Panel Report

Hume Planning Scheme Amendments C207 and C208
Sunbury South and Lancefield Road Precinct Structure Plans
Permit Application Nos P18858, P18854, P18855

15 December 2017

Panel Report pursuant to section 25 and section 96E of the Act

Figure 2 Sunbury South Future Urban Structure

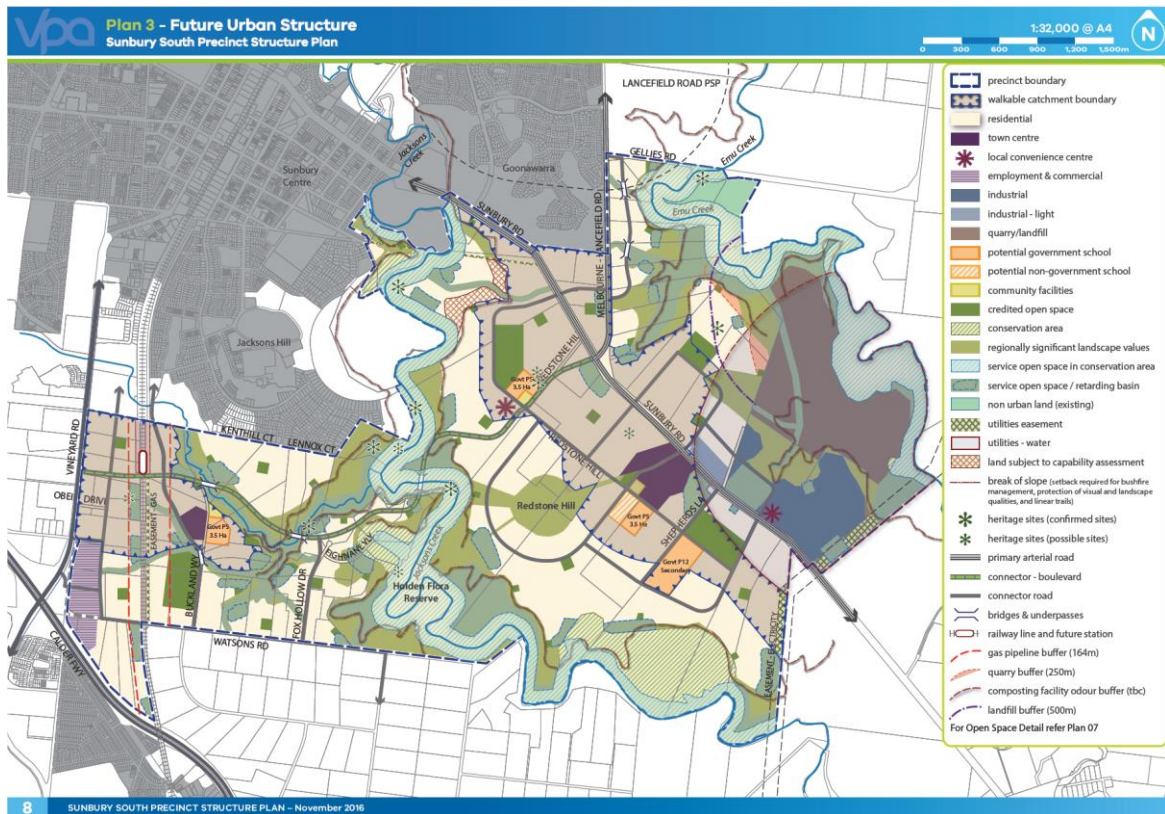
The PSP FUS plan shows quarry and landfill buffers around the Hi-Quality regional landfill facility at the eastern end of the Sunbury South PSP. The FUS also shows a composting buffer around the Veolia facility on land leased from Hi-Quality (refer to Figure 2 of this report).

12. Identify the quarry, landfill and composting buffers as 'Buffers/Potential Future Residential' on the Future Urban Structure Plan.
13. Amend the PSP Introduction and Vision to include:

15. Include a Clause within the UGZ9 which outlines the role of the buffers and the uses permitted within them.
 16. Show quarry and landfill buffers in the PSP Future Urban Structure Plan as 500 metres and composting facility buffer as 1,300 metres.

Figure 4 - Plan 12, Utilities, Sunbury South Precinct Structure Plan

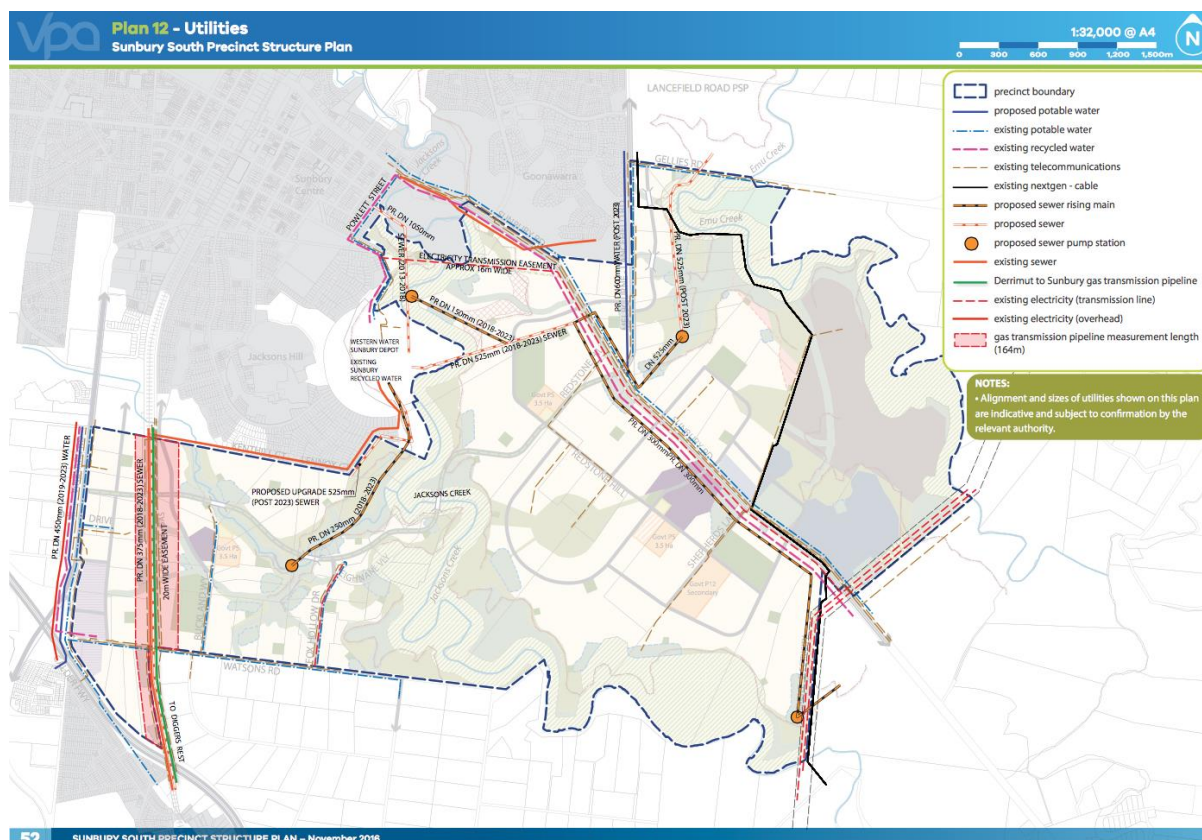
The Utilities Plan (Plan 12, Sunbury South PSP) shows the gas pipeline measurement length of 164 metres around this easement (see the far left of Figure 4). This affects a relatively small part of the overall PSP area, and includes land identified on the exhibited FUS as:

The PSP notes that, given the challenging topography of the area and the high-pressure gas pipeline, the Harpers Creek town centre is offset from the future Sunbury South railway line, but is planned to have strong connections to it. The government primary school is also located outside the pipeline measurement length.

Specific provision – Referral to gas transmission pipeline operator. An application to use land for any of the following uses within the ‘gas pipeline measurement length’ shown on Plan 12 Utilities in the incorporated *Sunbury South Precinct Structure Plan* must be referred to the gas transmission pipeline operator:

Figure 6 Proposed revised location of primary and secondary (P-12) school Redstone Hill

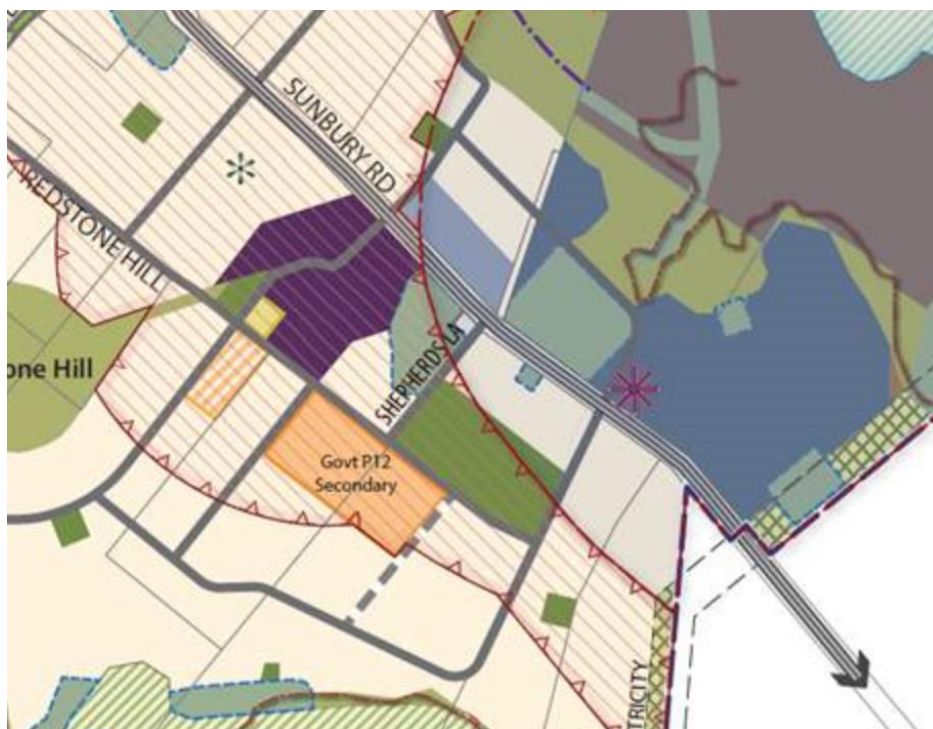
The VPA proposed a revised location for a combined P-12 school in place of separate primary and secondary schools in the Redstone Hill area as shown in Figures 5 and 6 (The secondary school was incorrectly marked as P-12 in the exhibited version). The change was made by the VPA in response to a request from the Department of Education and Training (DET). (Although the Panel is to clear on whether DET has confirmed its final position.) Hongfengshi International Property Investment Pty Ltd (Submission C207-56) objected to the location of the primary school on its land in the exhibited PSP. The proposed change involved removing the primary school from the location depicted on Hongfengshi's land as requested, but instead locating part of the P-12 school on that land. Hongfengshi also objected to the modified configuration. The exhibited secondary school location is on land owned by Sunbury Realty (Submission C207-59). The revised location straddles Sunbury Realty and Hongfengshi land.

Sunbury Realty called evidence from Mr Panozzo. He gave evidence that the secondary school should be relocated to the north-west of the precinct, to the location presently identified for the northern-most primary school.

- The Redstone Hill secondary school (now a P-12 school) is appropriately located in the modified location as proposed by the VPA and as shown in Figure 6.
- In the event that DET changes its' preferred location, further consultation would be required with the affected landowner/s to arrive at a satisfactory configuration.

Figure 7 Proposed application of the SUZ10 to the Craiglee and Ben Eadie properties

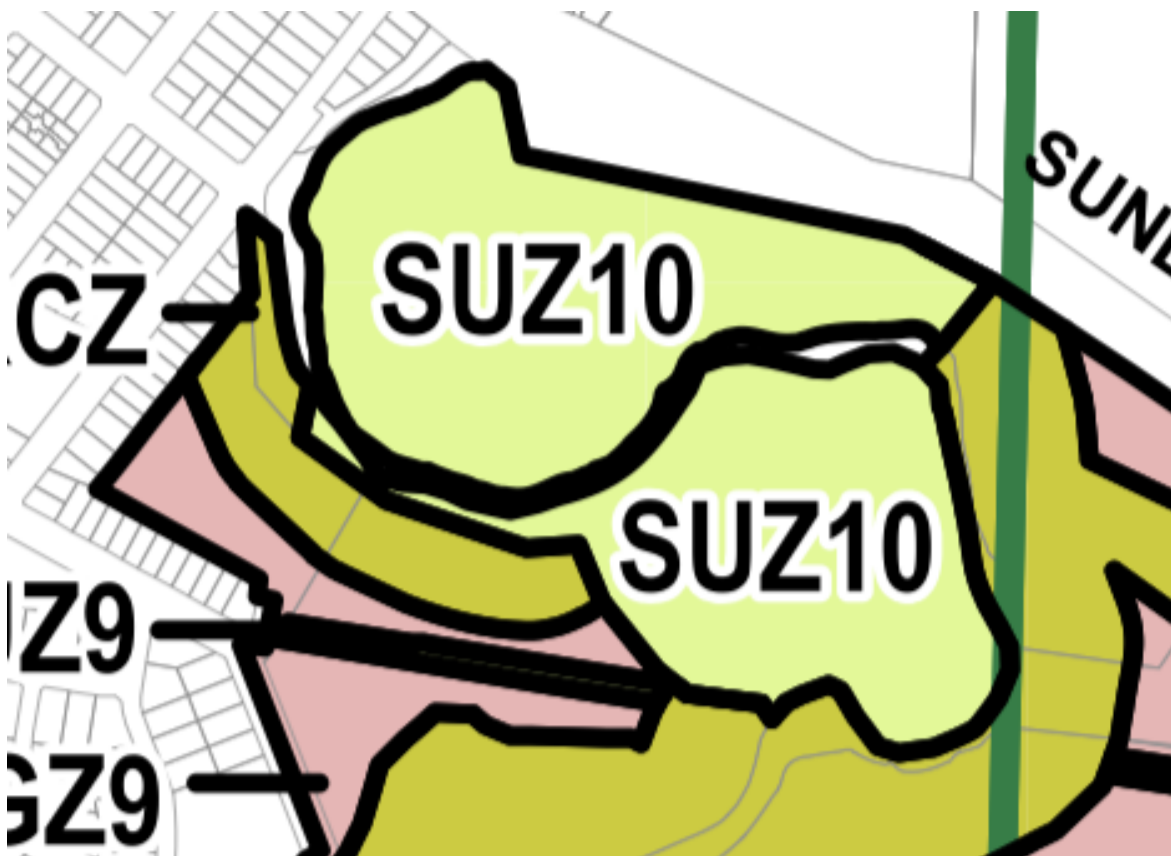
The Craiglee and Ben Eadie properties are external to the PSP, but form part of Amendment C207. Whilst not part of the PSP, the land has an interface with it.

The site has been used as a vineyard and winery since early last century and since that time it has become surrounded by urban development. The Amendment seeks to include the site within a Special Use Zone 10 to facilitate the continued use and development of the land for a vineyard and to allow for complementary and compatible tourism activities to be undertaken in conjunction with these uses.

- Delete the condition requiring certain uses (such as restaurant or conference centre) are only permissible if they are in conjunction with a winery use of the site

- Delete various superfluous decision guidelines

- Update the concept plan to exclude existing buildings from the area designated as '*creek environs (to be kept free of buildings)*'
- Correct mapping to accurately reflect the location of the creek and break of slope.

Figure 8 Mesh proposal for Vineyard Road employment area

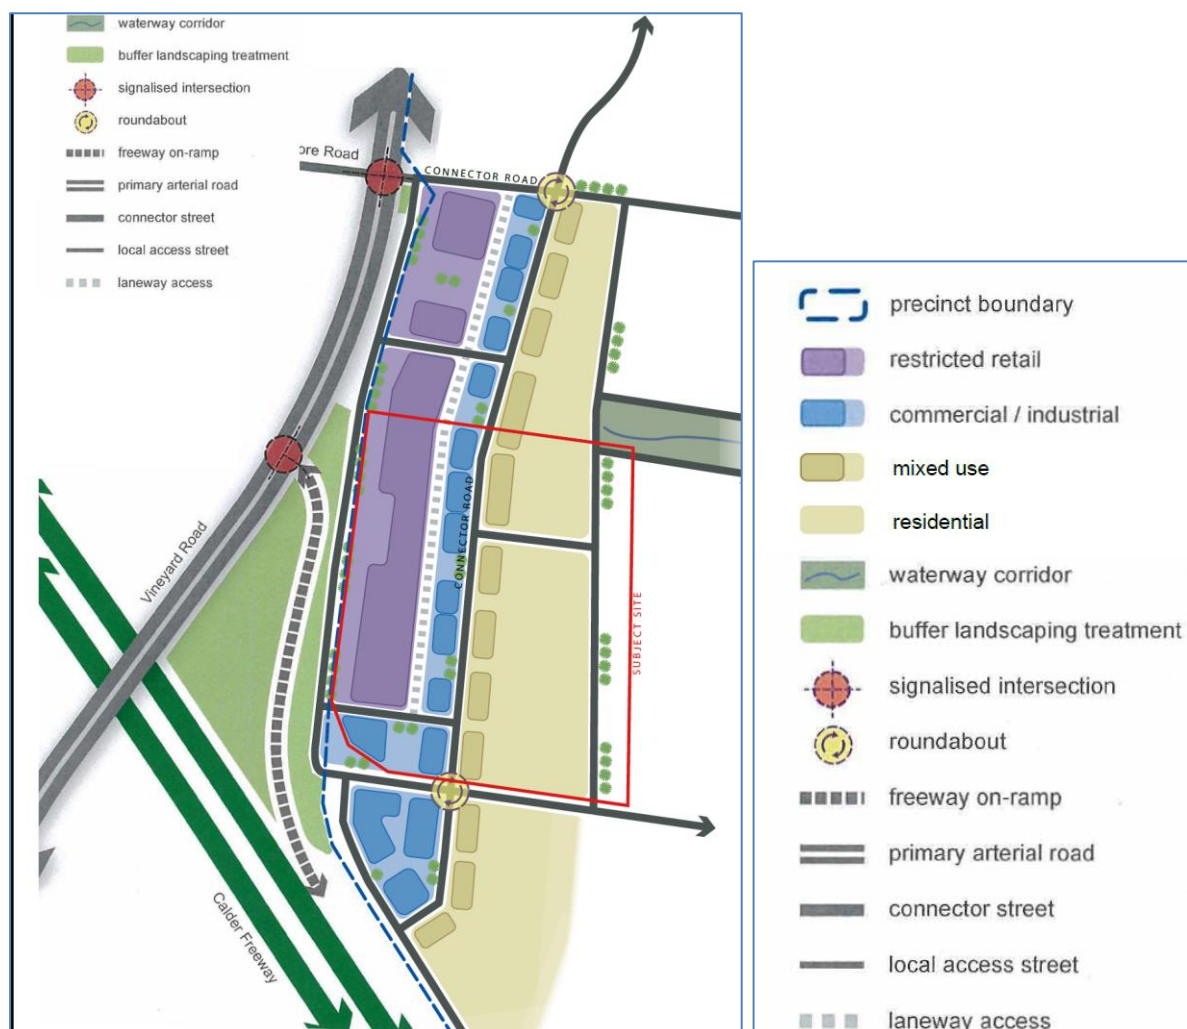
This submission represented a new position, not outlined in the original submission. Mesh submitted that this new position is, at least in part, in response to the changed access arrangements to Vineyard Road.

The proposed arrangement is as shown in Figure 7 and features substantially reconfigured restricted retail and commercial/industrial precincts and the inclusion of mixed use land abutting the north south connector road. Overall, the proposal is a reduction of employment land from 6.75 hectares to 4.22 hectares, and a corresponding increase in residential land.

In support of the proposal, Mesh submitted that the proposal represents *“a more progressive approach which generates employment and which will provide an enhanced, higher density walkable catchment for the future train station would preferably involve adoption of a mixed use approach”*. It further submitted: *“The built form of the employment uses and the housing outcomes including So Ho opportunities, in conjunction with the overall streetscape character are very important considerations.”*

32. The VPA and Council should further investigate options for the reconfiguration of employment land in the Old Vineyard Road area.
33. Amend Sunbury South Precinct Structure Plan Plan 9 – Street Network to move the north-south connector street the depth of one development lot to the west from its location shown on the exhibited PSP Plan.

Figure 11 Plan from Expert Evidence of Mr Czarny

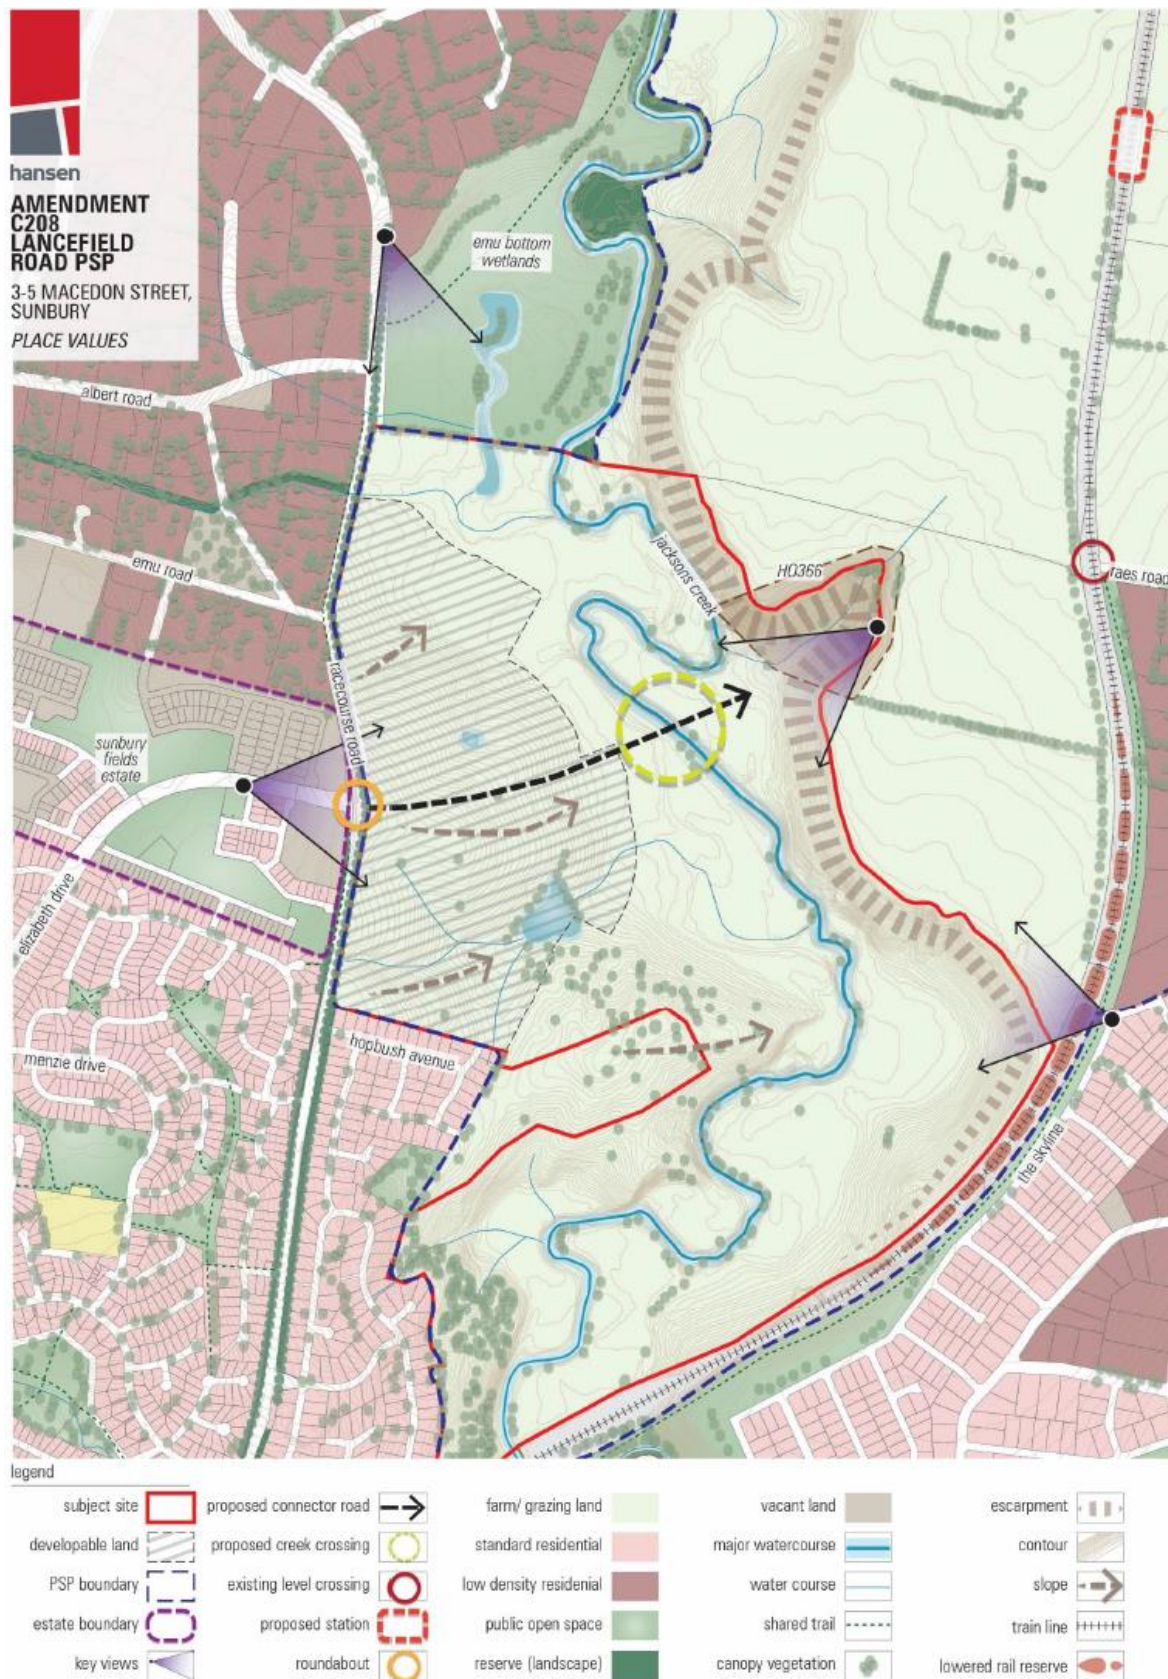
Mr Czarny considered that on the basis of this strategic background, there are clear opportunities for residential development on the eastern side of Racecourse Road, and in particular, on the elevated land overlooking Jacksons Creek as a continuum of the conventional residential subdivision occurring south along Hopbush Avenue.

Mr Czarny did, however, consider that there should be more rigid parameters in relation to the siting and layout of a residential subdivision to ensure that there is sensitivity to the significant landscape of the Jacksons Creek corridor and the associated landscape values of the precinct.

- The reduced development area as provided for in the plan presented by the VPA (Figure 10) is supported.
- Additional parameters for development should be drafted and included in the PSP, as recommended by Mr Czarny.

Figure 12 Revised Balbethan Residential Concept Plan

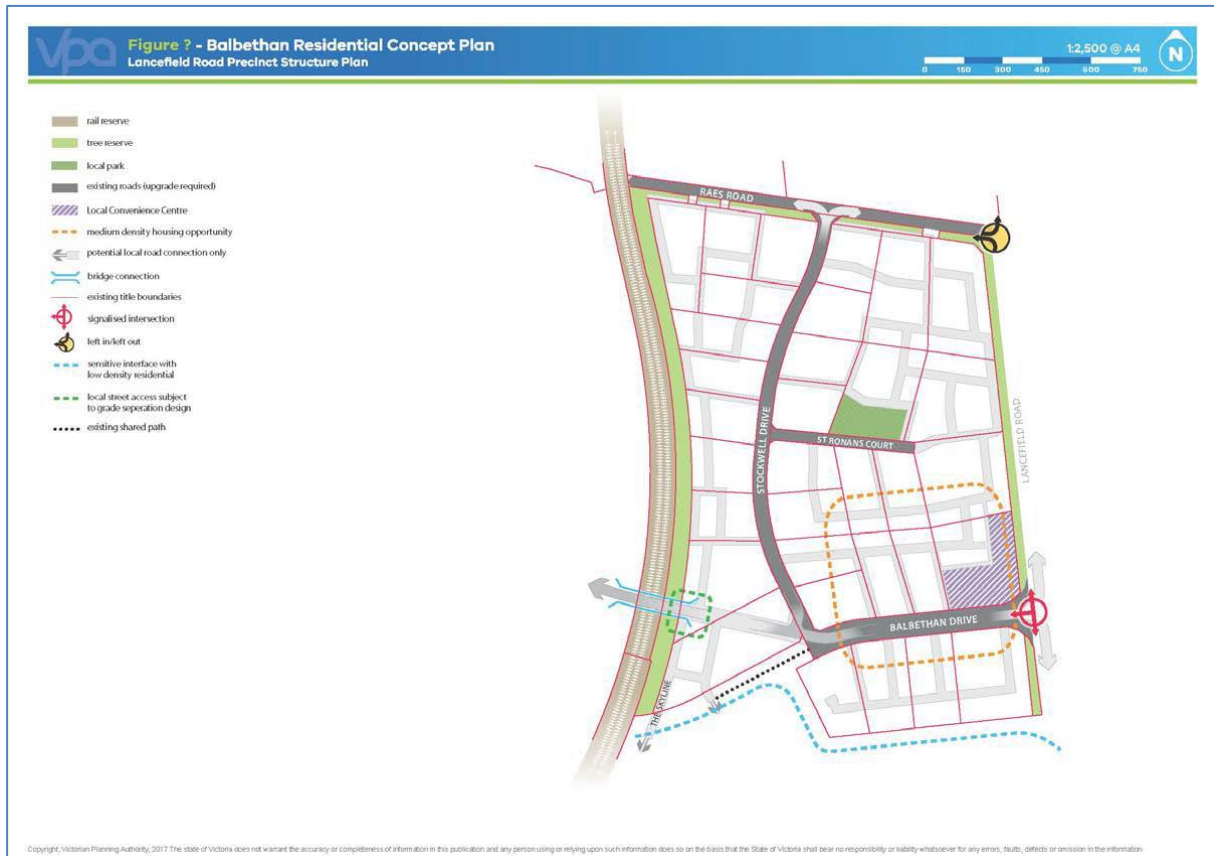
The Balbethan Residential Concept Plan is at Figure 1 in the Lancefield Road PSP.¹⁸

A revised Balbethan Residential Concept Plan has since been prepared as shown in Figure 12.

75. Further revise the Balbethan Residential Concept Plan to incorporate a shared path along the rail reserve from The Skyline to Raes Road, and change the ‘Tree

Reserve' designation to 'Plantation Reserve' and 'Plantation and Drainage Reserve'.

74. Replace Figure 1 in the Lancefield Road PSP with the revised Balbethan Residential Concept Plan prepared post-exhibition by the VPA.
